REV.	REMARKS	DATE	DWN	CHK	APP	Q.A.	NO.	DIA.	LGT	TYPE	WASHER
	PROJECT NO. IM-091-1 (36)										
	STATE BRIDGE NO. 38										
	MATERIAL: <u>A1370</u>										
	<u>A1370</u> ELECTRODES: —										
	HOLES: —										
	SHOP BOLTS: —										
	SURFACE PREP. & PAINT:										
	<u>GALV. AFTER FAB (ASTM-A123)</u>

DESCRIPTION: BEAM END RS. ABUTS. 1&2	DRAWN BY	DATE
JOB:	JPF	6-03
<u>US ROUTE 5</u>	CHKD BY	
<u>OVER I-91</u>	EJ	
<u>HARTLAND, VT.</u>	APPROV BY	
	Q.A.

CUSTOMER: F.W. WHITCOMB	JOB NO.	DRG. NO.
CASCO BAY STEEL STRUCTURES, INC.	198	M2
75 SPRING HILL ROAD SACO, MAINE 04072	097	REV. Δ
PHONE (207) 282-7360 FAX. (207) 282-1179

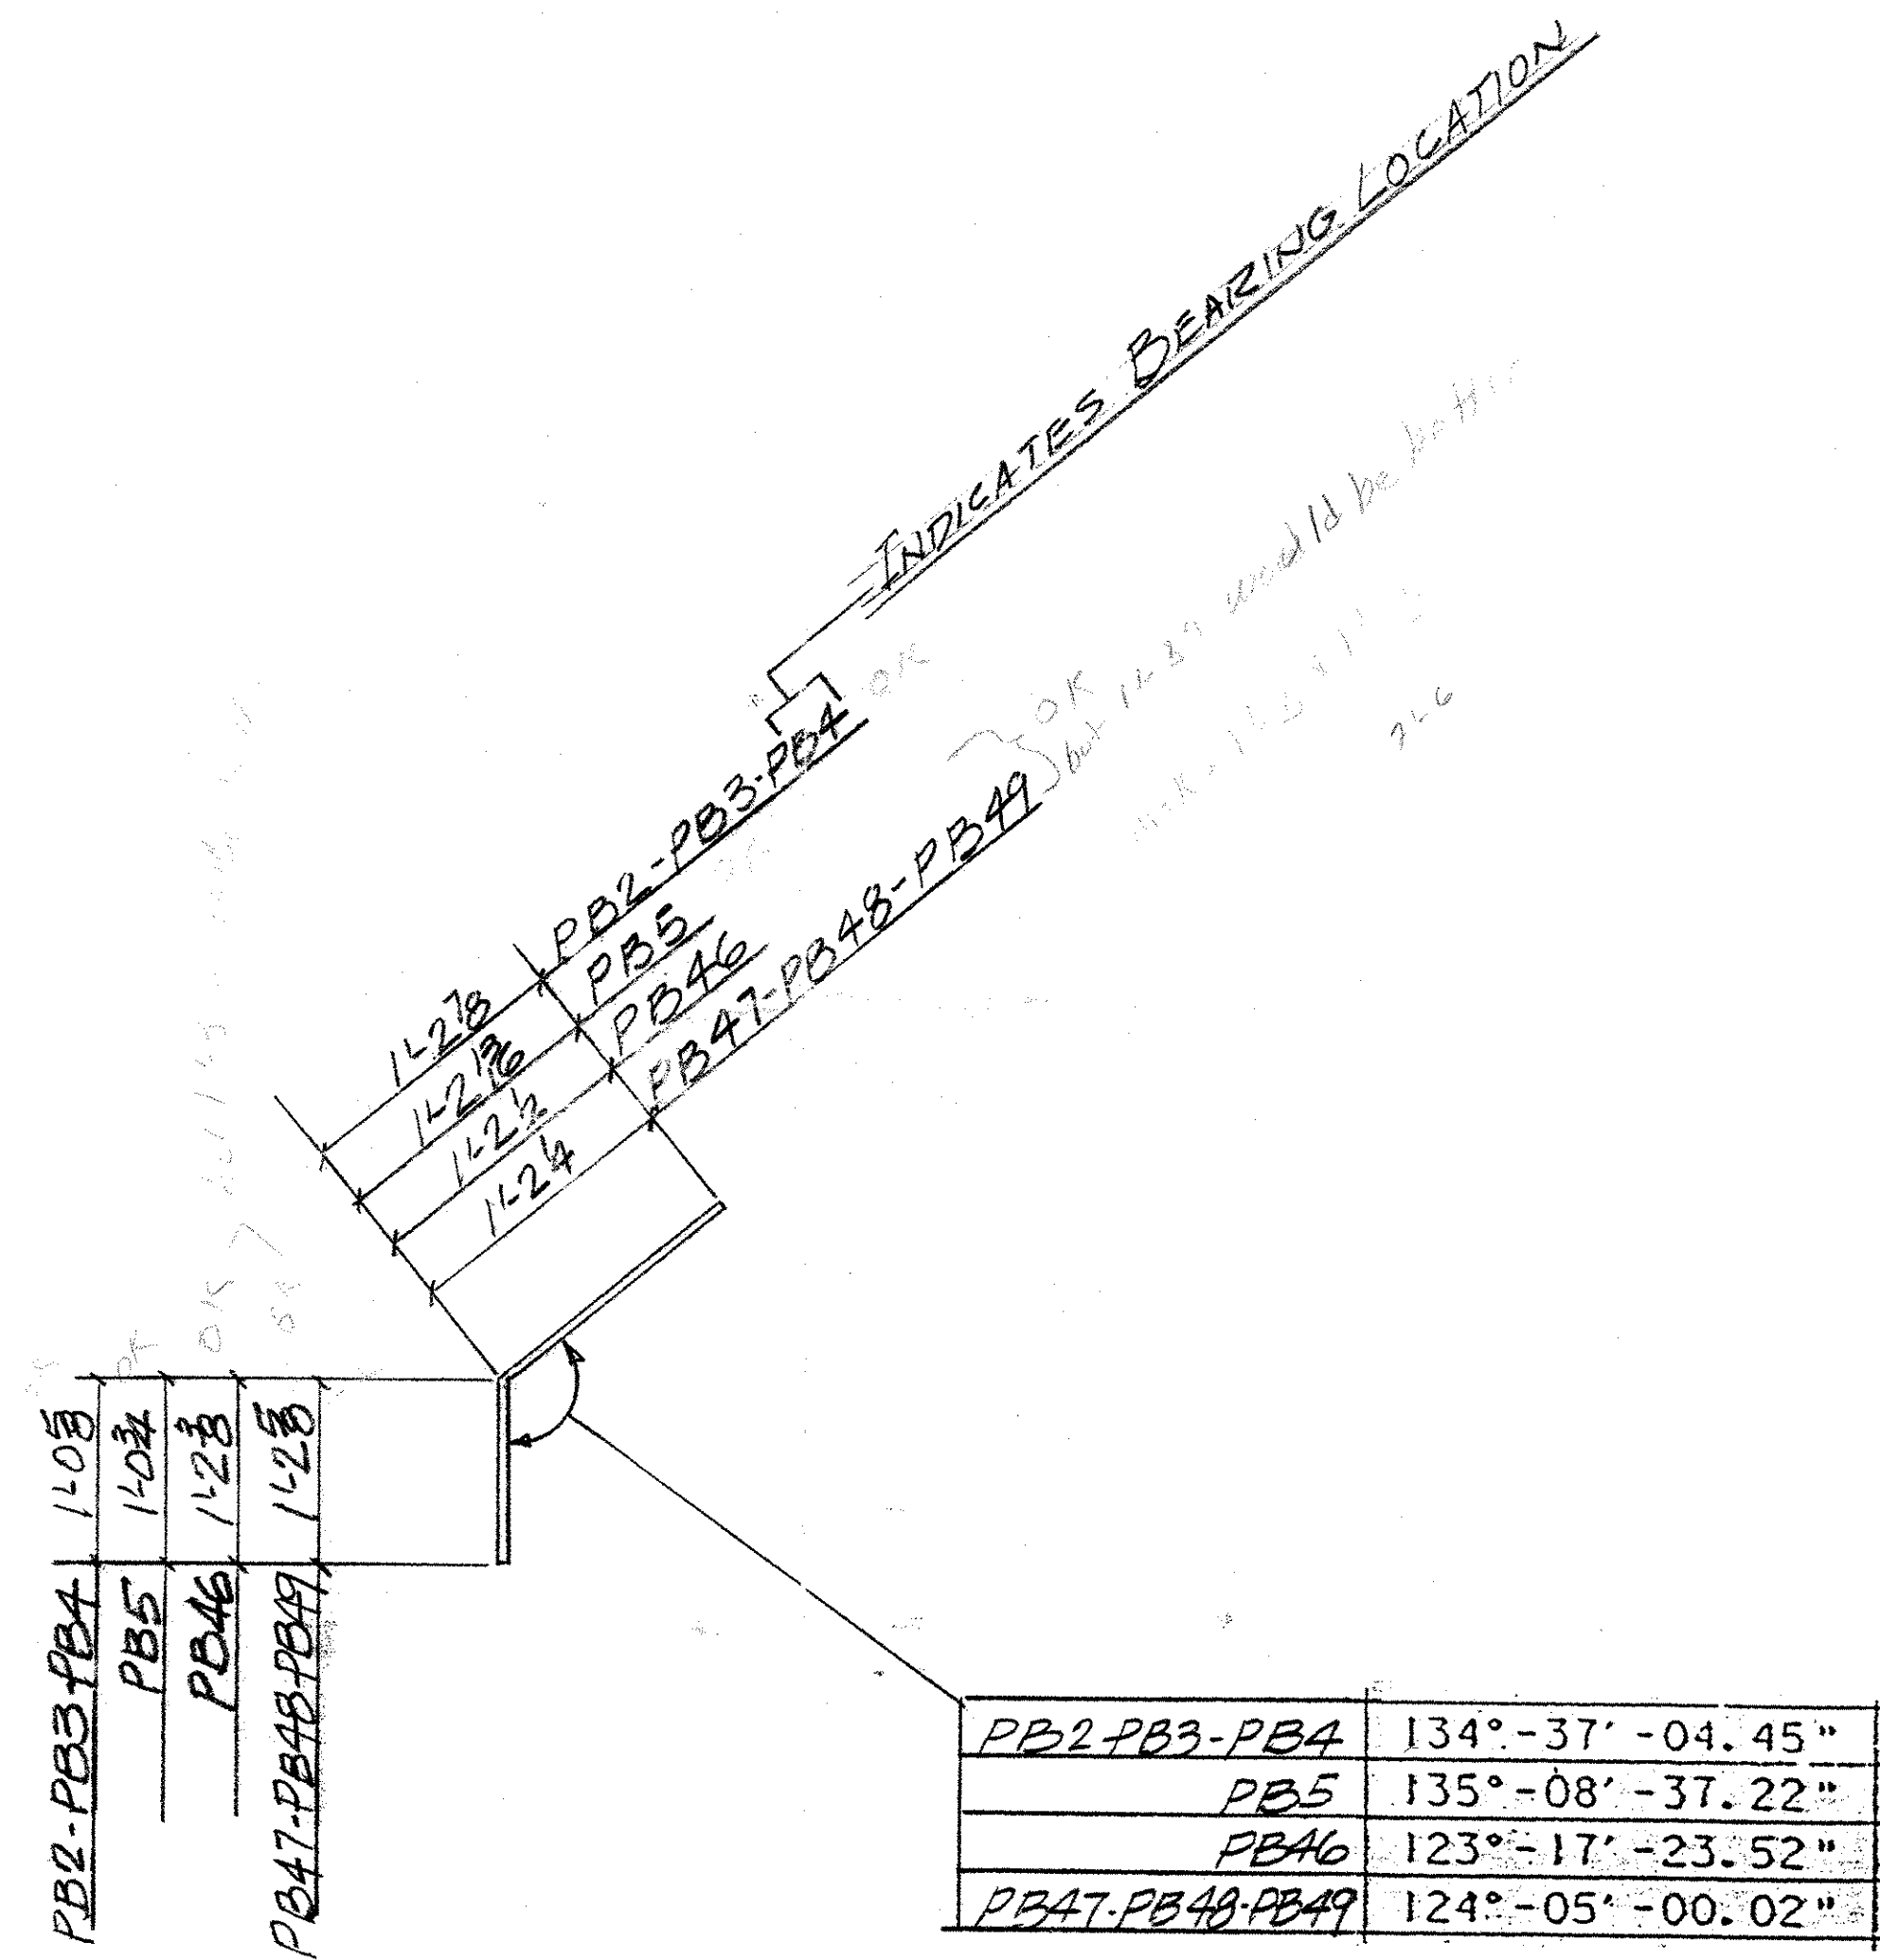
Bearing height at centerline of bearing is 3.16" for B1-B5 and 2.66" for B46-B50. Verify with Contractor (J. Hollar of F. Whitcomb) that shim plates are not being used. Update heights accordingly.

Absolutely
VERIFY
